**World Forum for Harmonization of Vehicle Regulations****Working Party on Lighting and Light-Signalling****Sixty-seventh session**

**UN Regulation No. 48 (Installation of lighting and light-signalling devices)****Proposal for Supplement 10 to the 04 Series of amendments****Submitted by the expert from the Working Party "Brussels 1952"\***

The text reproduced below was prepared by the expert from the Working Party "Brussels 1952" (GTB) to introduce into the Regulation, revised provisions for reducing geometric visibility angles for direction indicator lamps, stop lamps, front and rear position lamps and retro reflectors. This proposal is submitted for discussion and if deemed acceptable it will be submitted as part of a collective amendment including the associated amendments to Regulations Nos. 3, 6 and 7. The modifications to the existing text of the Regulation are marked in bold for new or strikethrough for deleted characters.

FIGURE (see paragraph 6.5.)

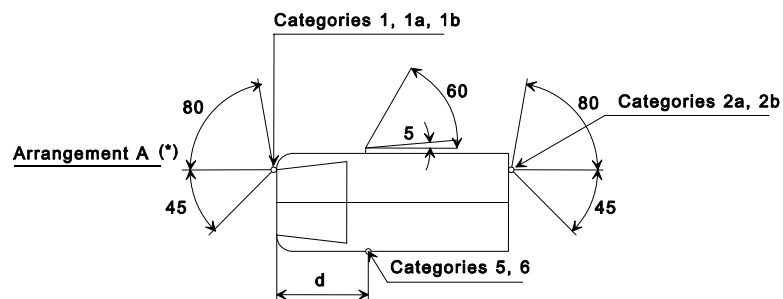
~~For  $M_1$  and  $N_1$  category vehicles, the value of  $45^\circ$  inward for the direction indicator lamps of categories 1, 1a or 1b, whose lower edge of the apparent surface is less than 750 mm above the ground, may be reduced to  $20^\circ$  under the horizontal plane containing the reference axis of this lamp.~~

**For the direction indicator lamps of categories 1, 1a, ~~or~~ 1b, 2a and 2b mounted below 750 mm (measured according to the provisions of paragraph 5.8.1), the inward angle of  $45^\circ$  may be reduced to  $20^\circ$  under the H plane.**

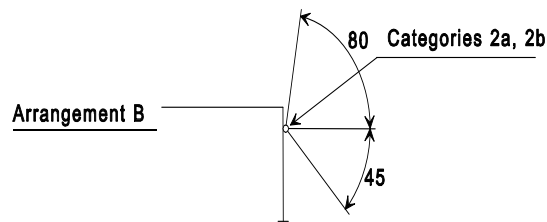
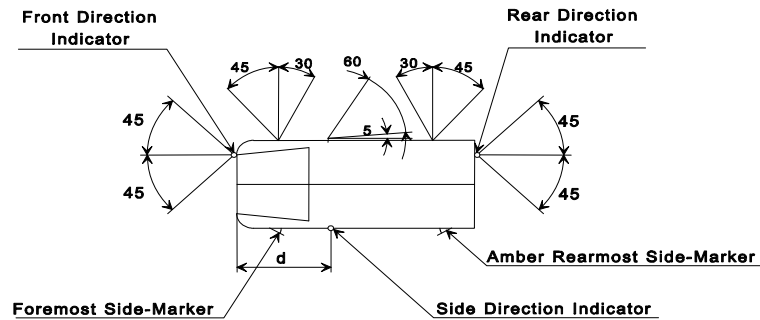
~~Vertical angles:  $15^\circ$  above and below the horizontal for direction indicator lamps of categories 1, 1a, 1b, 2a, 2b and 5. The vertical angle below the horizontal may be reduced to  $5^\circ$  if the lamps are less than 750 mm above the ground;  $30^\circ$  above and  $5^\circ$  below the horizontal for direction indicator lamps of category 6. The vertical angle above the horizontal may be reduced to  $5^\circ$  if the optional rear lamps are not less than 2,100 mm above the ground.~~

**Vertical angles:  $15^\circ$  above and below the horizontal for direction indicator lamps of categories 1, 1a, 1b, 2a, 2b and 5.**

**However:**

- where a lamp is mounted below 750 mm (measured according to the provisions of paragraph 5.8.1), the downward angle of  $15^\circ$  may be reduced to  $5^\circ$ ;
- where an optional rear lamp is mounted above 2,100 mm (measured according to the provisions of paragraph 5.8.1) the upward angle of  $15^\circ$  may be reduced to  $5^\circ$ .
